RE: Suitability of additional ramp at 225 Bungaribee Rd, Blacktown NSW 2148

1. Summary

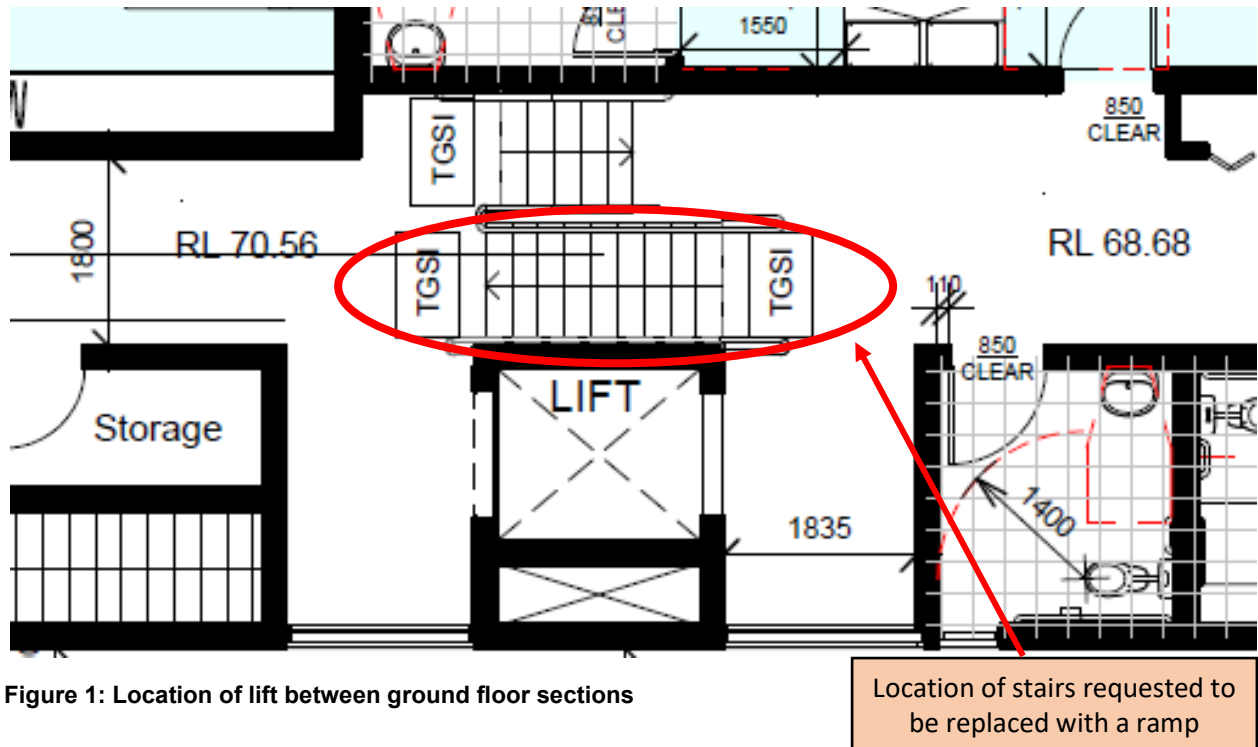
The building contains 11 sole occupancy units and has been provided with 2 accessible sole occupancy units at the ground level. As the proposed building is to be constructed over a slope, the ground floor is split into two sections, with the entrance being at RL 70.56 and the rear section being at RL 68.68. The layout is illustrated at figure 1 below:

Access to the sole occupancy units, as well as the common areas, is via a lift situated between the entrance and the rear section, as shown in figure 1 above. The lift contains two openings at either side and will be programmed to be able to stop at the floor level for each of these sections. The BCA definition for *accessway* in a building is referring to the term *continuous accessible path of travel* in Clause 6 AS 1428.1. That excludes listed impediments however does not exclude lifts. BCA clause D3.3 (b) further defines the requirements for lifts in accessible buildings:

As shown on plans, the lift is provided with openings on each level of the first floor i.e., the lift has been designed to service both levels of the first floor.

Figure 2: Length required for a 1:14 ramp

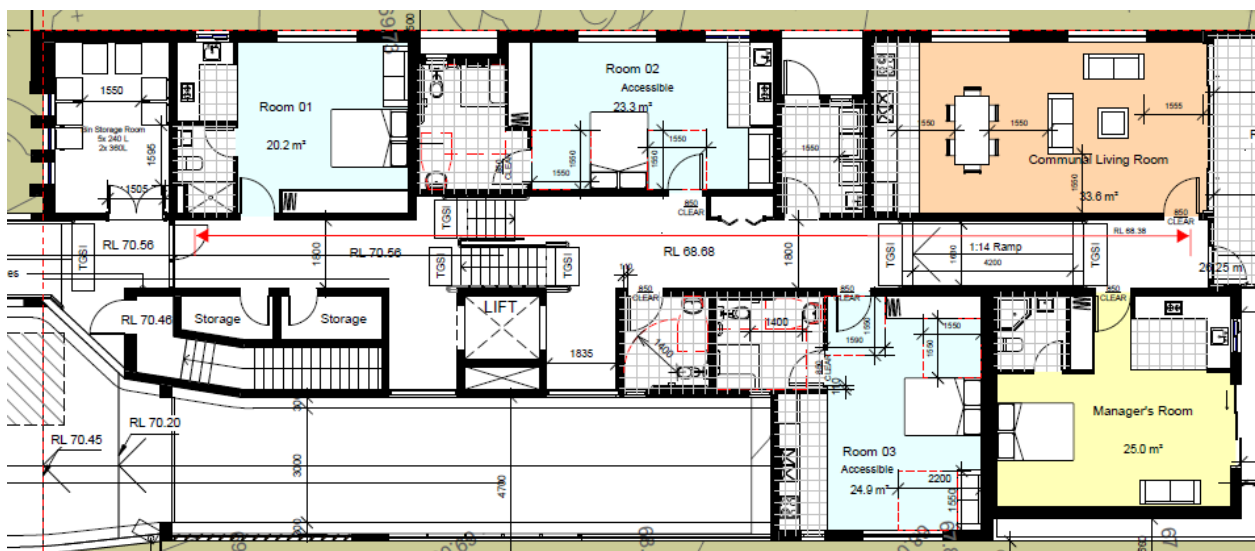
Similarly, there is not enough space in the current development to install a ramp of 1:14 which may traverse the 1.88 m between the sections of the ground floor. This would require the ramp to be over 30 m long including required landings. As the length of the building is only 31.5 m such a ramp would not only take up an unreasonable amount of space, it will be unreasonable to require occupants to travel back and forth over a 30 m long ramp to reach their unit when they could instead use a lift. Figure 2 below illustrates the length required for an AS1428.1 compliant ramp in relation to the building not considering the additional space for landings:

Given the 1.88 m difference in floor level between the two sections at the ground floor, the use of a passenger lift to travel between these floors levels is the only practical manner in which BCA compliant access can be provided for this building.

Figure 3: Location of hypothetical ramp

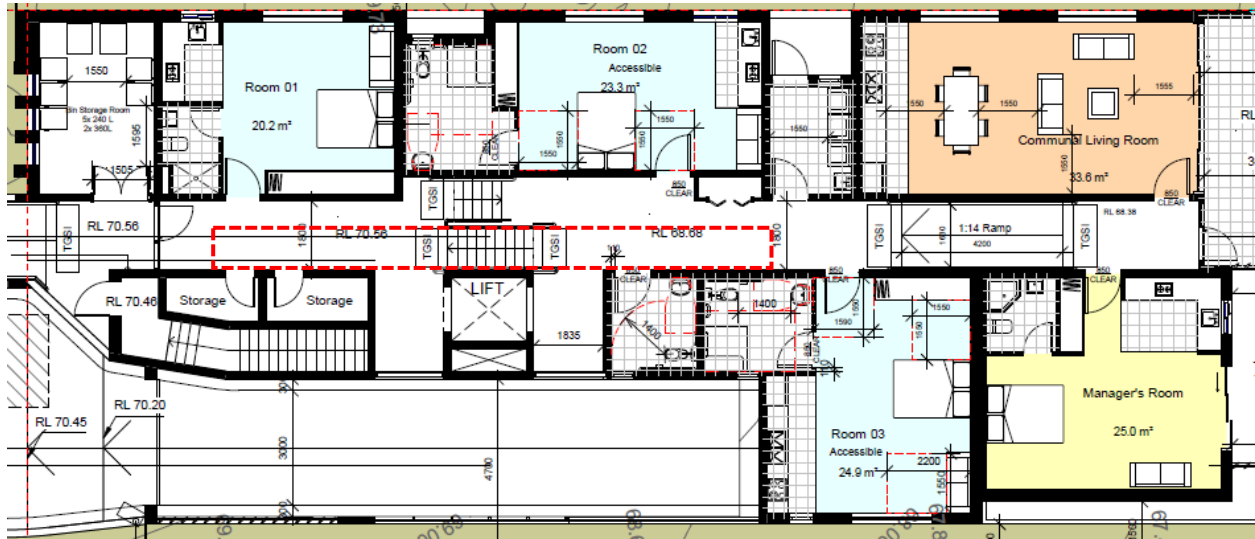
Even if a ramp was to hypothetically be installed in lieu of the stairs, as shown in figure 3 above, use of a ramp would result in non-complying circulation spaces at doorways and actual blockage of access into the communal living room, managers room, communal laundry, common area toilet and render access to the first floor via the lift impossible. This results in a non-compliance with clauses D3.1 as common areas are no longer accessible and D3.2 as the lift from the basement carpark can no longer be used to access the ground floor.

As the width of the corridor is only 1.8 m at parts, installing a ramp within this corridor will result in non-compliances with BCA clause D1.6 regarding the fire safety in relation to paths of travel to exits, as the passageway used for egress at Room 01 and Room 2 is less than 1 m.

Installing a ramp within the building corridor will also result in inadequate circulation spaces at the doorways outside Room 01 and Room 02 as required under AS1428.1, which is of particular significance for Room 02 as this is an accessible sole occupancy unit. Additionally, a ramp will also potentially result in inadequate circulation space at the entrance doorway as well as the laundry. Inadequate circulation space is a non-compliance under BCA clause D3.3.

Replacing the stairs with a ramp will result in non-compliances regarding access for people with disabilities at BCA clauses D3.1, D3.2 and D3.3, as well as non-compliances with D1.6 regarding fire safety egress. It is recommended to consider that the non-compliances that arise, in particular for people with disabilities, substantially outweigh any minor benefit to people with a disability that would be obtained from having a secondary ramp in the event the lifts are not operational.
